Choose the plate files to machine

A small, precise manufacturing set

Pro must choose which main/diverter plate variants should actually be made and return exact file-by-file instructions. Each manufacturing STEP must contain one custom plate solid. Keep wall, valve and assembly references outside the fabricator package. Specify filenames, dimensions, purpose, stock, quantities, isolated previews and verification. The six current standalone candidates are listed in 06_PLATE_ONLY_FILE_GUIDE.txt.

Inner plate measured face

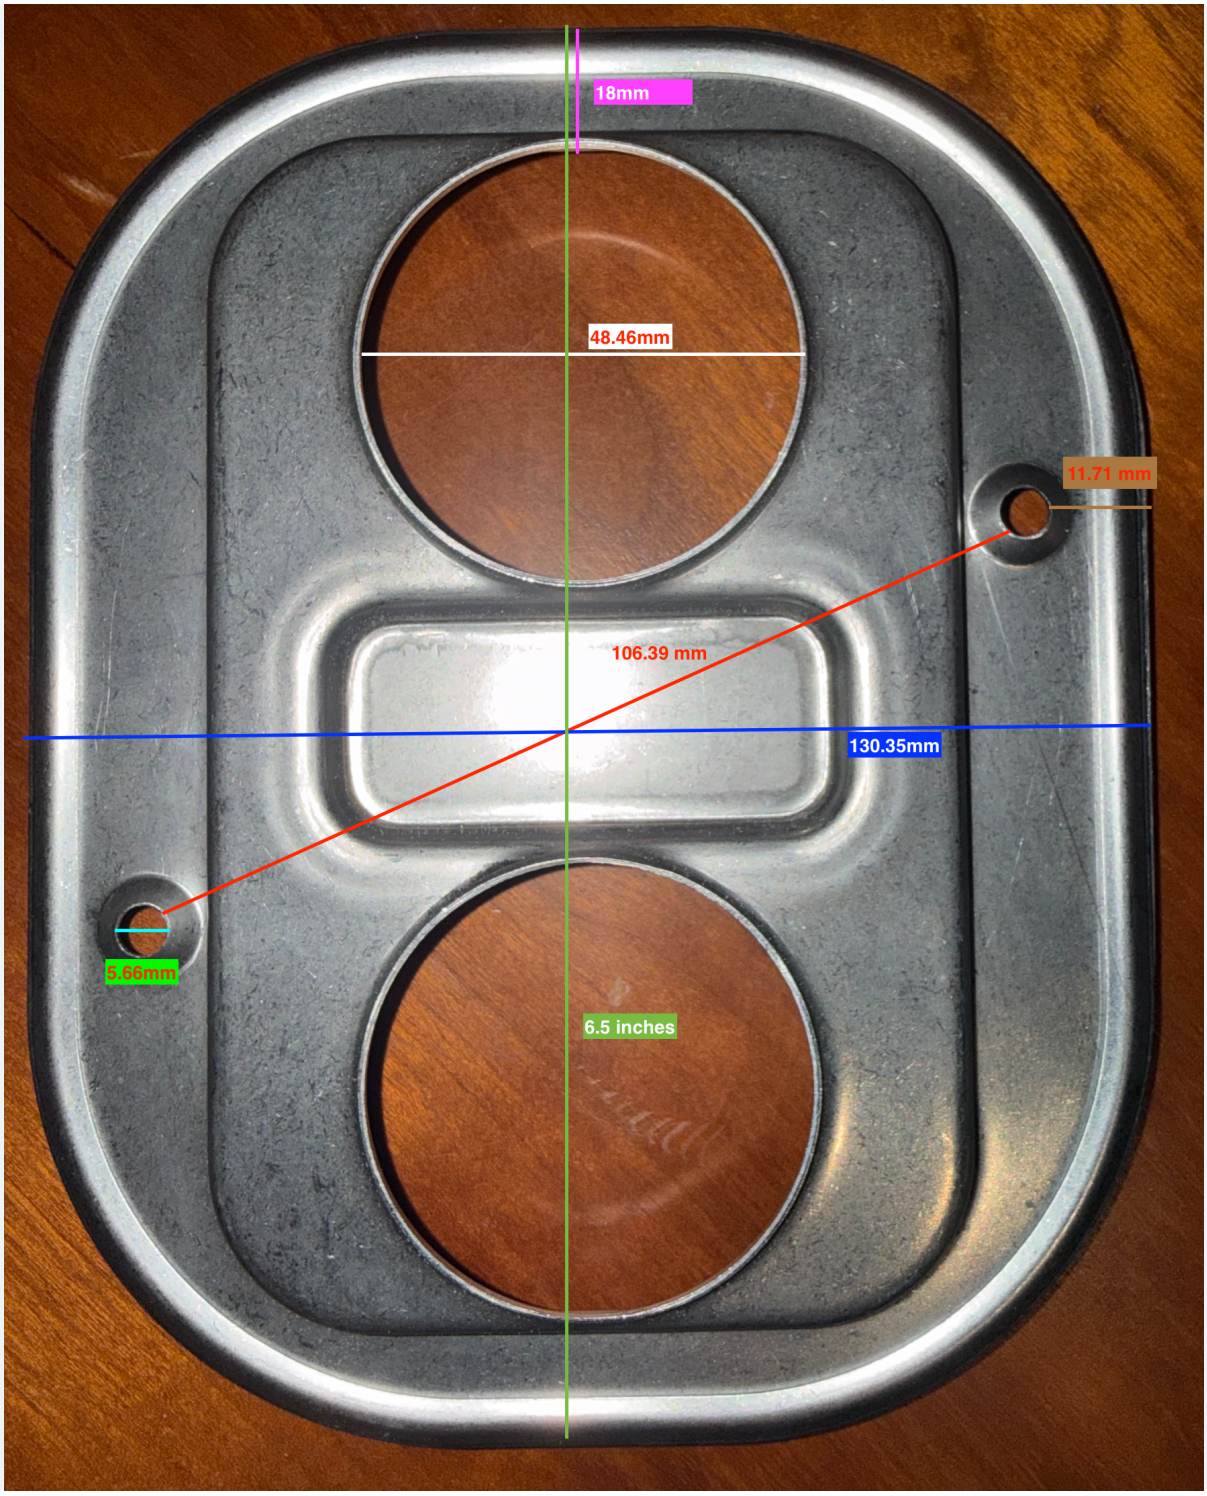
Measured within one plane; the owner considers the caliper readings highly accurate. No tip-depth correction applies. Width 130.35 mm; upper opening 48.46 mm; tape height 165.10 mm.

106.39 mm is nearest-hole-edge gap; 11.71 mm is hole edge to outside rim; SW hole is 5.66 mm; NE diameter is unknown. Use the calipers ahead of scan estimates for these measured dimensions. Foam/depth readings are separate; no numerical accuracy bound was supplied.

Decorative cover measured face

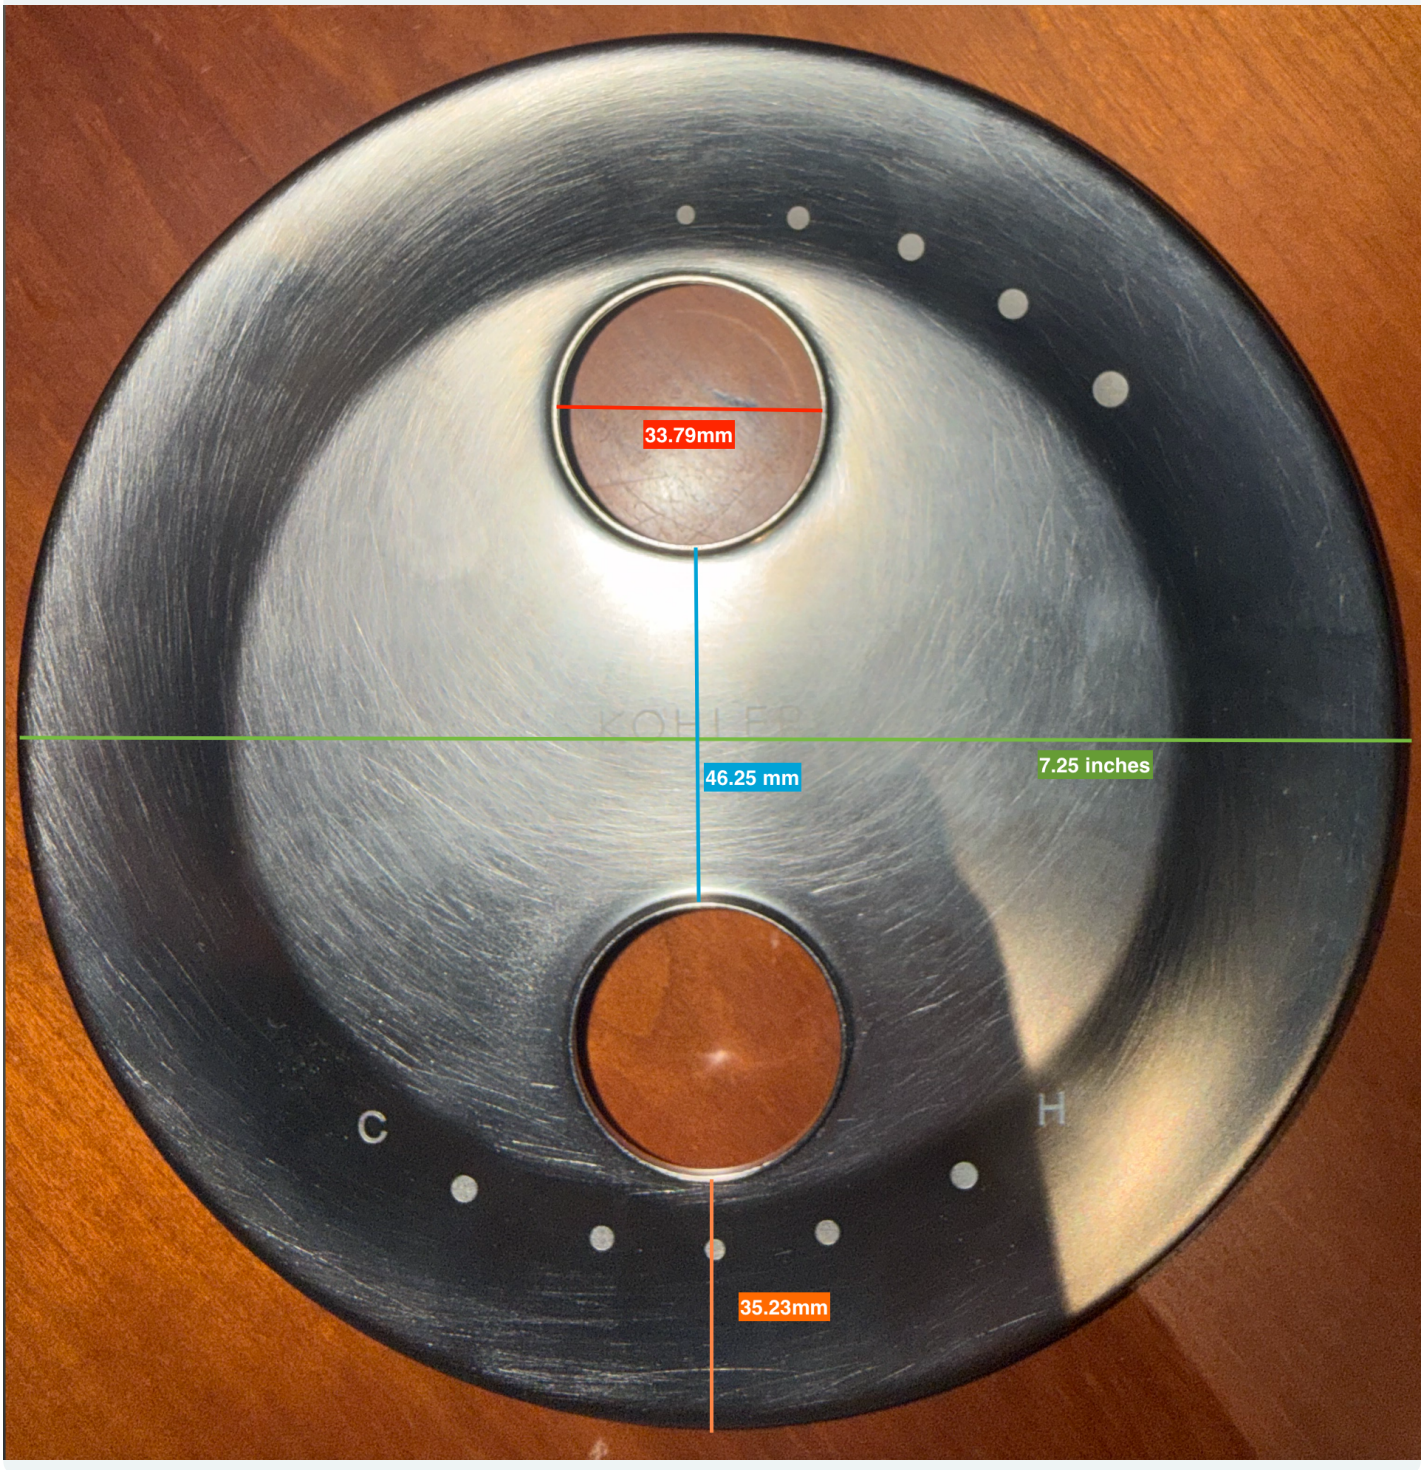
Outside diameter 7.25 inches = 184.15 mm. Upper opening 33.79 mm. The blue 46.25 mm is between nearest inside opening edges. Orange 35.23 mm runs from lower inside opening edge to outside bottom rim.

Lower opening diameter and rear cavity are unmeasured. These front dimensions do not establish nut clearance, handle engagement or the installed center.

Current main aperture

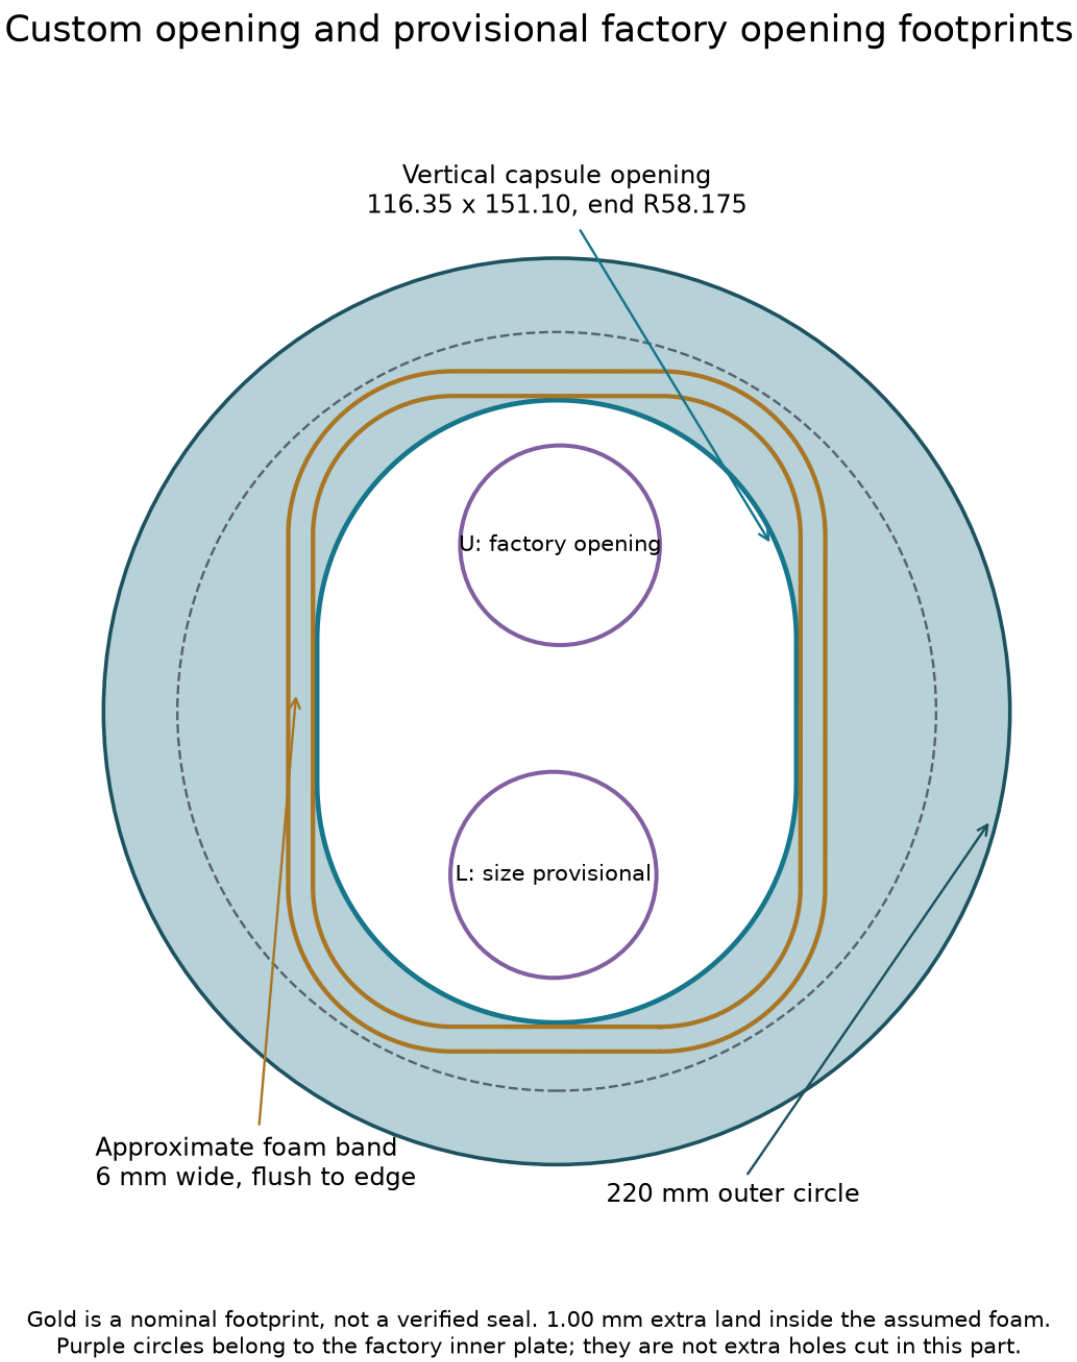
Main outside diameter 220 mm; centered vertical capsule 116.35 x 151.10 mm with R58.175 ends. Gold represents assumed edge-flush foam. The lower opening circle and some placement dimensions remain assumptions.

The nominal extra land inside the 6 mm foam is only 1 mm. The smallest scoped projected hardware clearance is about 1.61 mm before unresolved scan/placement errors. These are review targets, not accepted field tolerances.

Main and diverter size choice

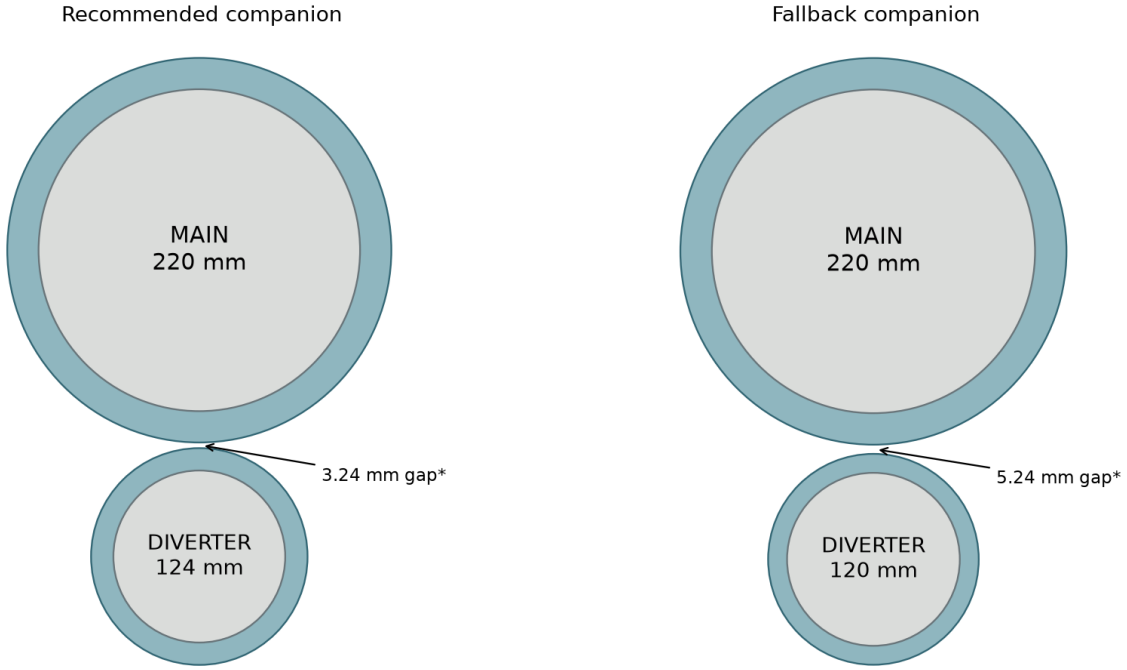
*Original placement estimate. Across recorded scenarios, selected-pair gap is 3.06-5.21 mm, not error bounds. Increasing either diameter consumes half that increase from the gap. Verify with both real covers.

Earlier placements predict only about 3-5 mm between the larger pair. These are scenarios, not an uncertainty range. The actual diverter seal footprint and paired clearance need the expert fit trial.

Recommended trial: main 220 mm and diverter 124/80 mm. The separate diverter fallback is 120/80 mm. Keep both backing circles concentric with their actual covers.

Earlier locating-tab experiment

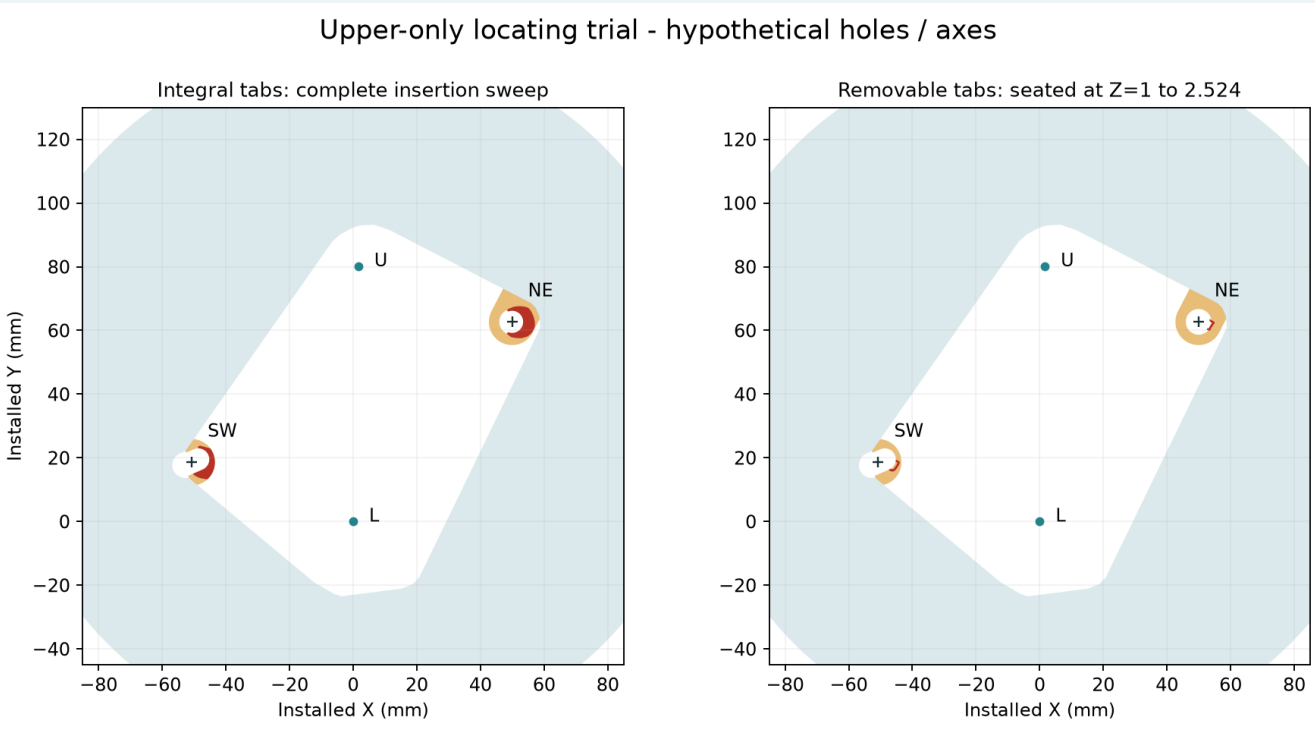
Amber: added tab metal. Red: projected captured-surface interference. Not a released mounting design.

This earlier diagonal opening added metal tabs with hypothetical holes/axes. Red marks conditional captured-surface interference in insertion or seated trials. It is not the FT01 capsule design.

The trial does not rule out every notch. A notch removes material; a tab adds it. Pro should independently assess restraint, adjustment, foam land, bearing, depth and complete insertion/removal before recommending a locator variant.
